**PLANS AND DOCUMENTS
referred to in the PDA
DEVELOPMENT APPROVAL**

Approval no: DEV2016/811

**Jimboomba Celestino Master Plan Development within the Greater Flagstone Priority Development Area (PDA)
Cumulative Impact Assessment for Final Response to Item B-1 of Summary of Flood Investigation and
Stormwater Management Review document (received by Calibre on 19 January 2017).**

**RE: JIMBOOMBA CELESTINO MASTER PLANNED COMMUNITY, GREATER FLAGSTONE PDA
PROPOSED SCOPE TO ADDRESS FLOODING AND STORMWATER FLOODING ISSUES**

Figure 2: Flood Level Hydrograph Comparison at Payne Bridge (Cusack Lane) 1% AEP 30hr Duration

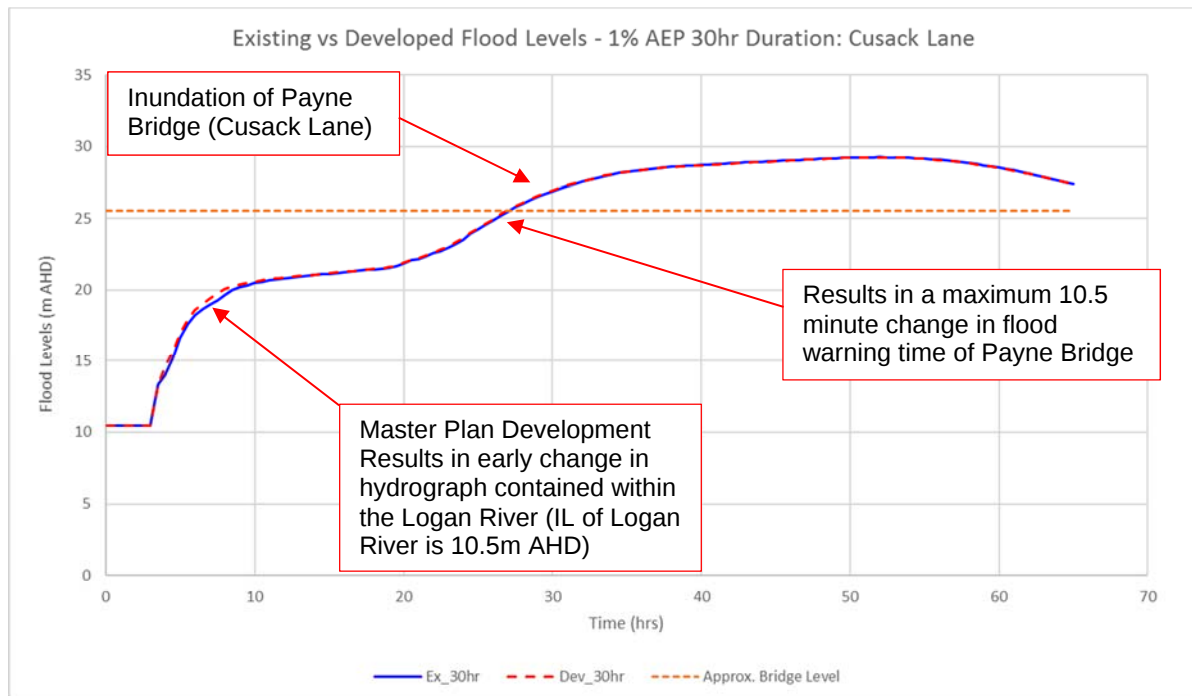
It is proposed to develop the site without detention basins for the majority of catchments. As the development is located well upstream of the river mouth, in order for such an approach to be acceptable, it will be necessary to demonstrate that the cumulative impact of similar development in the floodplain (based on the Council Planning Scheme and the PDA's defined by EDQ) will not result in an adverse impact, both in terms of flood levels and flood warning times in downstream areas affected by flooding.

Figure 1 below indicates the change in flood level hydrograph from existing (blue) to developed (red) 2km downstream of the development (at Cusack Lane) where the impact is most prominent.

As indicated in **Figure 2** there is an early increase in flood levels as a result of the master plan development. However, this is wholly contained within the Logan River and does not adversely affect flood warning times. Time until inundation of Payne Bridge or Cusack Lane occurs after 20 to 30 hours and is only reduced by a maximum

of 10.5 minutes. This insignificant change in flood warning time is not expected to hinder flood evacuation of residents considering the long lead up time to inundation.

Figure A – Urban Footprints in SEQ Regional Plan within Logan River Catchment U/S of Study Area

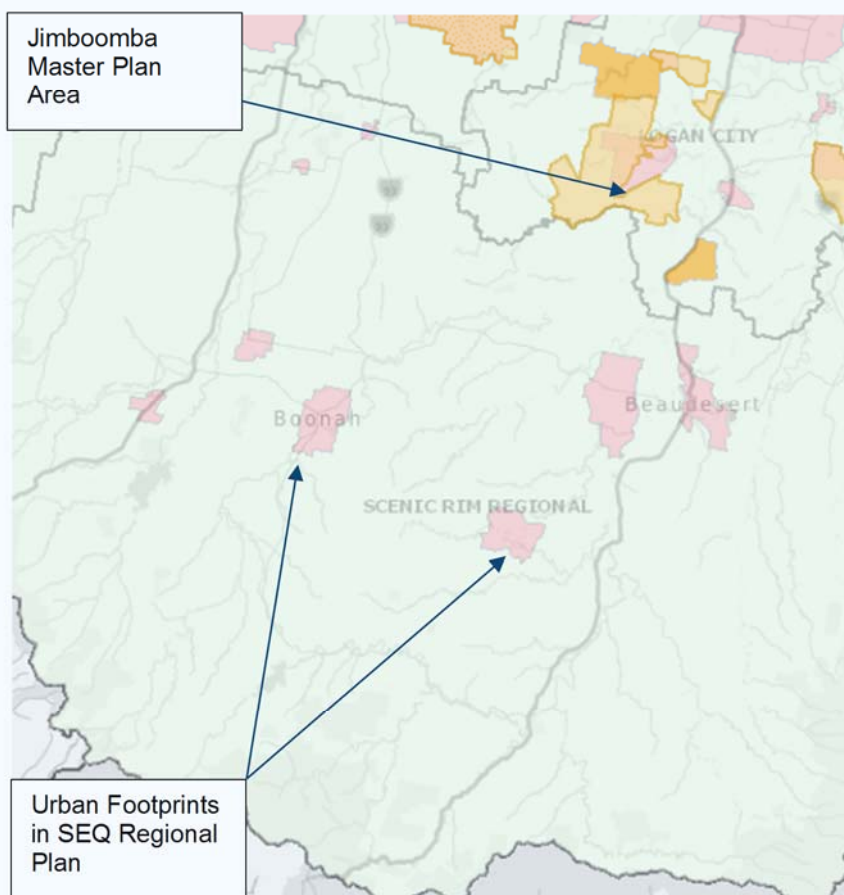
- Positioning of development in the overall catchment – further results are required to determine development impacts flood warning times further downstream and flood level increases before the peak.
- Cumulative impact – development of upstream catchment without detention.

XP-RAFTS modelling could be undertaken for an "ultimate case scenario (without detention)". However, as identified at the meeting there are limited urban footprint areas planned within the Logan River Catchment upstream of the structure plan and no other PDA's. Refer to the Figure A below. Since an "ultimate case scenario" would produce similar results to the current developed scenario, this extra modelling would not be warranted and therefore is not proposed.

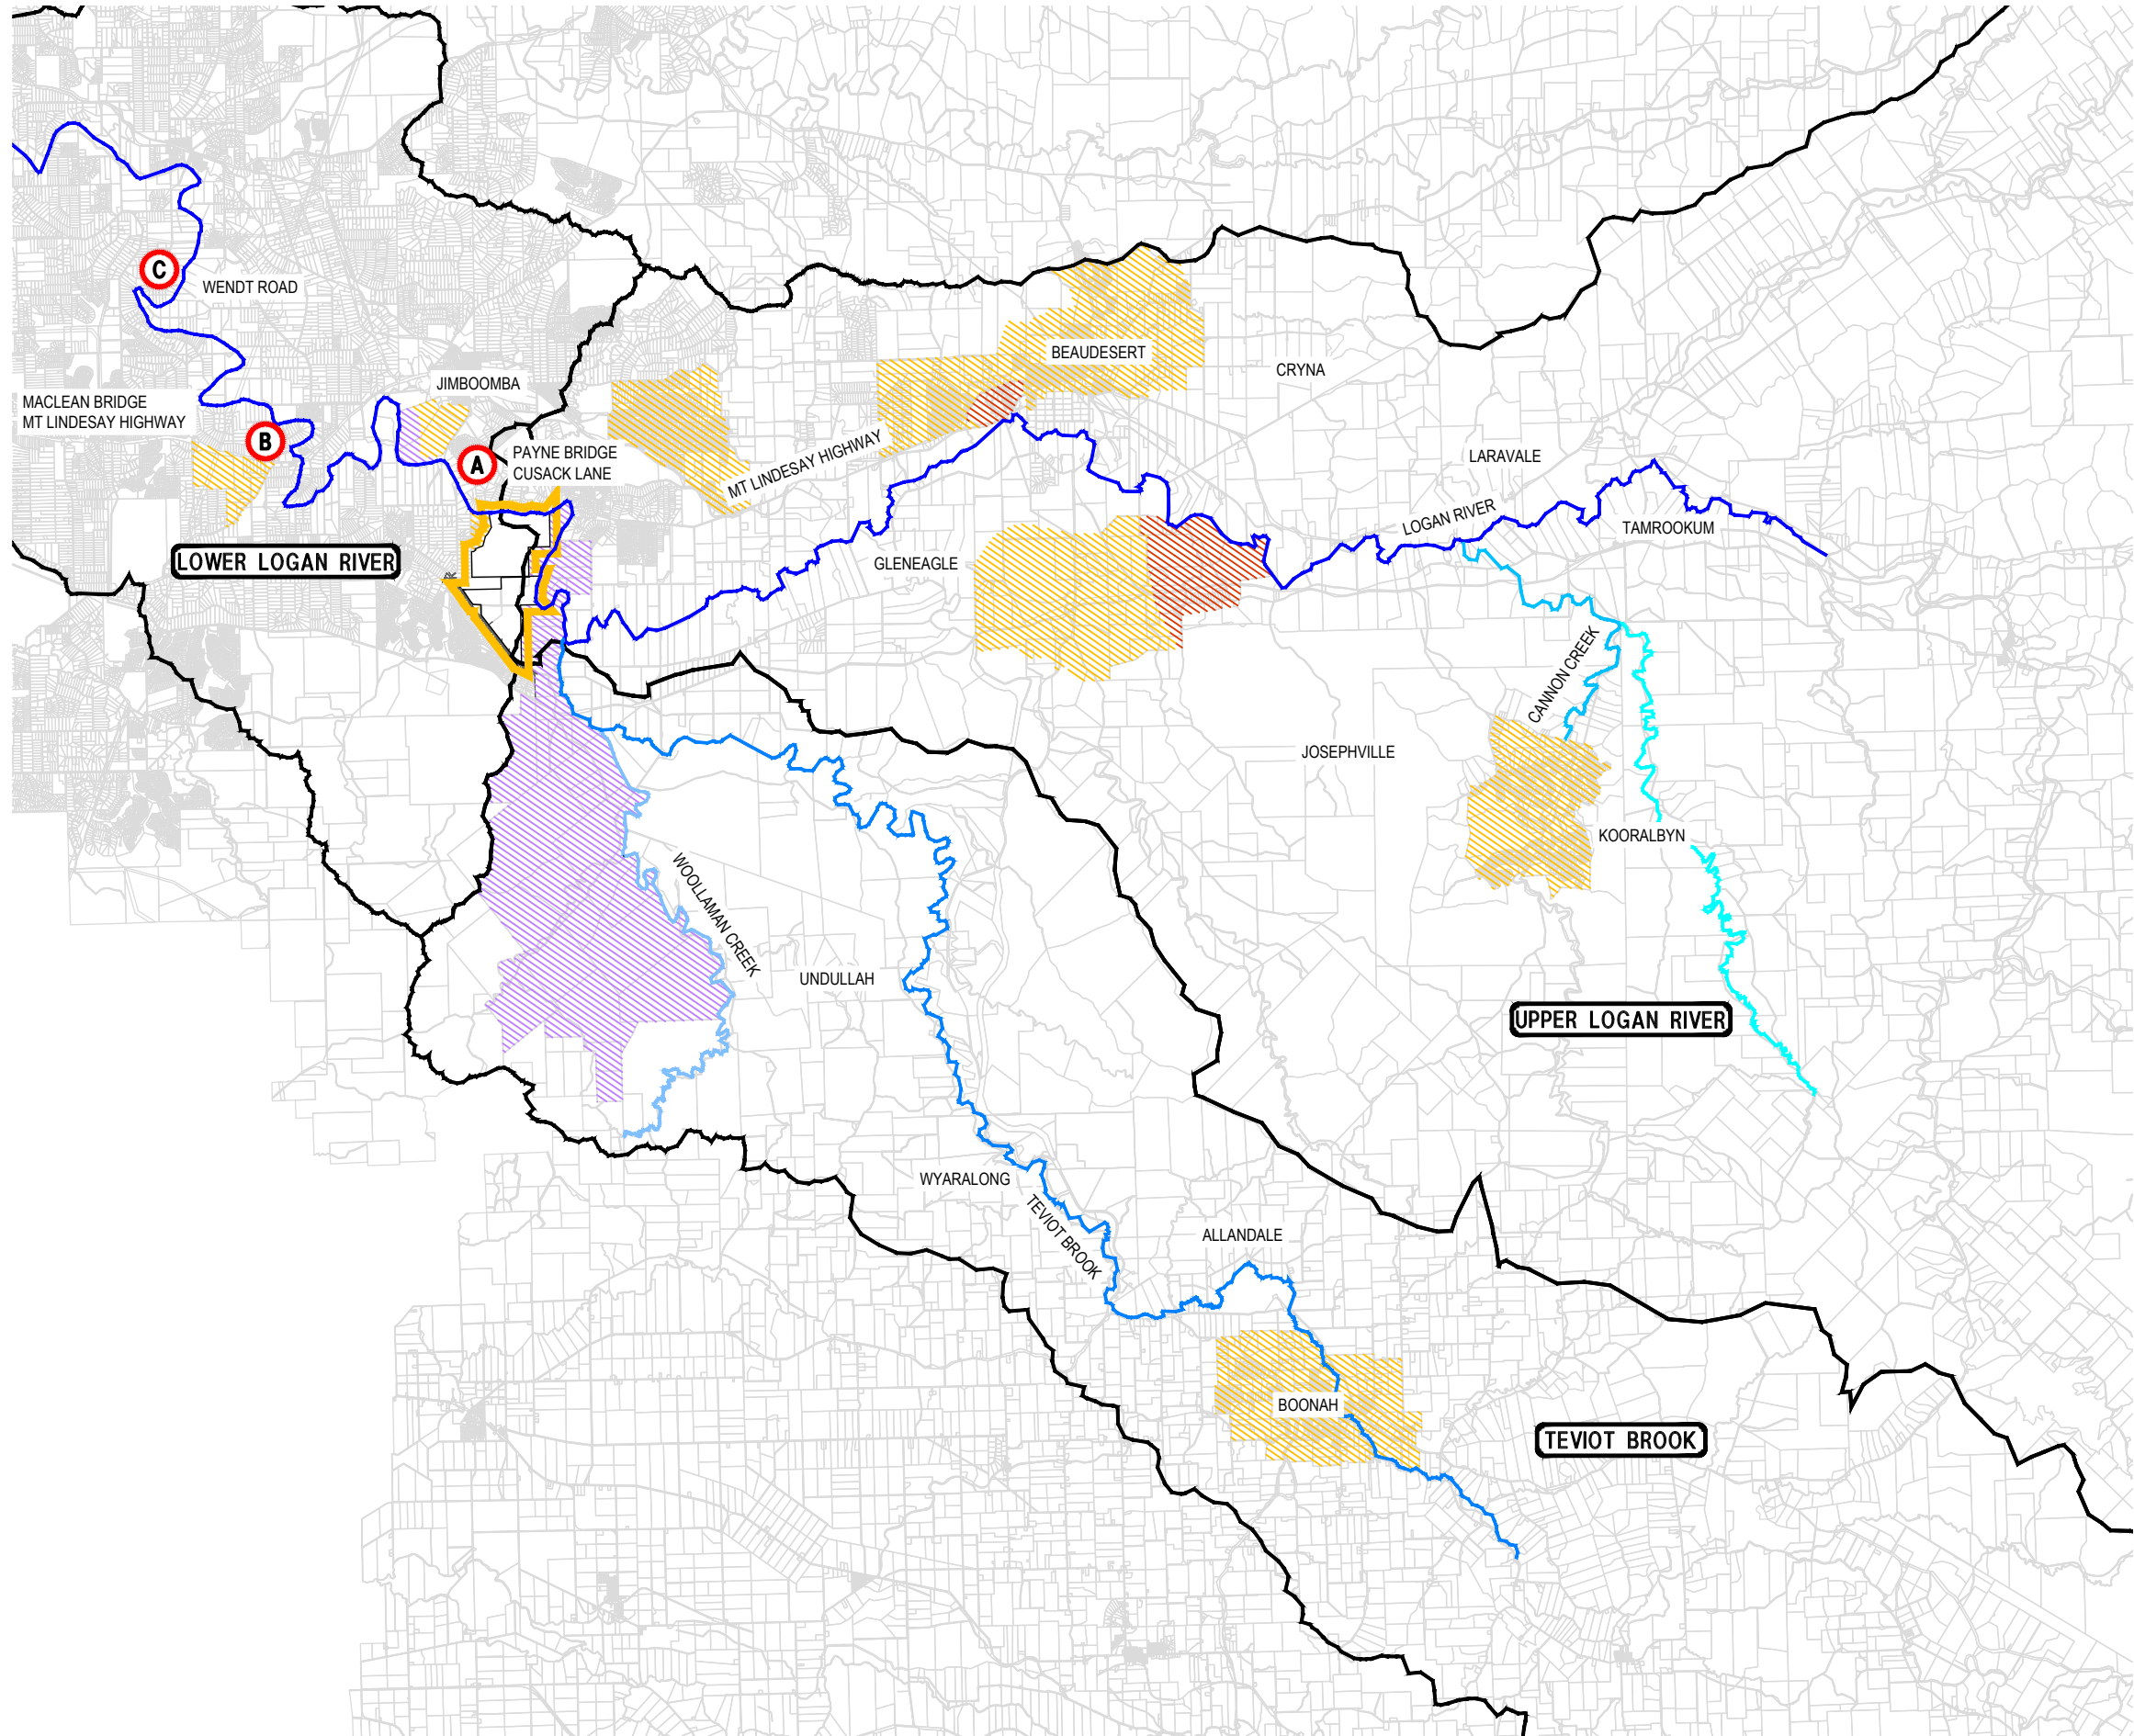
Lower Logan River, Upper Logan River and Teviot Brook XP-RAFTS models have been updated to incorporate potential future development upstream of the master plan development. The following development areas were incorporated in the *Potential Future Development Scenario*:

Refer to Drawing No. **B13343.W-SK13** in **Attachment 3** for development areas included in the *Potential Future Development Scenario*.
